Access Compliance Report

Public Rights-of-Way

Intersection ID: 6364	Main Street: SONOMA_VALLEY_DR	Cross Street: RHYNE_RD	Location: NE
ADA ID: 2EBB17C4B4E8	Ramp Type: Perp	Initial Pass/Fail: Fail	Overall Compliance: No
		Severity Score: 12.5

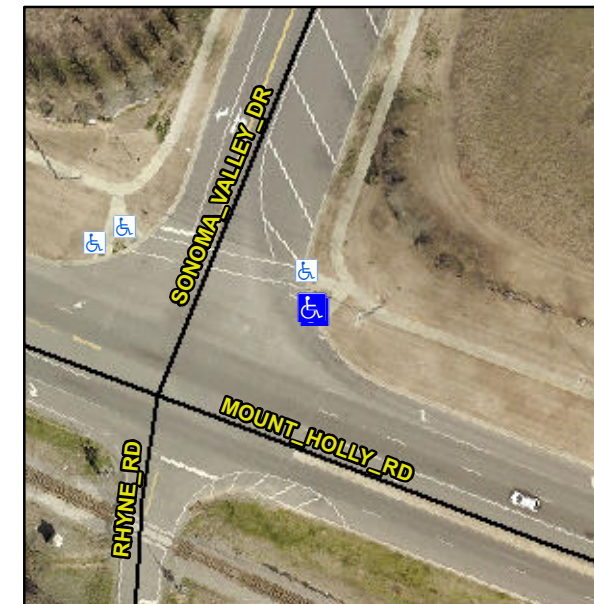
Not Found, R304.2.2

Compliance	Description	Data	Compliance	Description	Data
N/A	Ramp Length (in)	68.0	No	Ramp Slope (%)	9.0
Yes	Ramp Width (in)	59.0	Yes	Ramp XSlope (%)	0.8
N/A	Flare Type LT	N/A	N/A	Flare Type RT	N/A
N/A	Flare Slope LT (%)	N/A	N/A	Flare Slope RT (%)	N/A
N/A	Flare Traversable LT?	N/A	N/A	Flare Traversable RT?	N/A
N/A	Landing Length (in)	N/A	N/A	DWS Provided?	N/A
N/A	Landing Width (in)	N/A	N/A	DWS Contrast?	N/A
N/A	Landing Slope (%)	N/A	N/A	DWS Length (in)	N/A
N/A	Landing X Slope (%)	N/A	N/A	DWS Full Width?	N/A
N/A	Landing Curb? (Y/N)	N/A	N/A	DWS Offset (in)	N/A
N/A	Shared Landing?	N/A			
N/A	Gutter Ponding?	N/A	N/A	Gutter Slope (%)	N/A
N/A	Gutter Lip Ht (in)	N/A	N/A	Gutter X Slope (%)	N/A
N/A	Painted X Walk1?	No	N/A	Painted X Walk2?	N/A
	X Walk 1 Direction	To S		X Walk 2 Direction	N/A
N/A	X Walk 1 Width (in)	N/A	N/A	X Walk 2 Width (in)	N/A
	X Walk 1 Slope (%)	0.6		X Walk 2 Slope (%)	N/A
	X Walk 1 X Slope (%)	0.8		X Walk 2 X Slope (%)	N/A

Remove & Replace Entire Ramp.
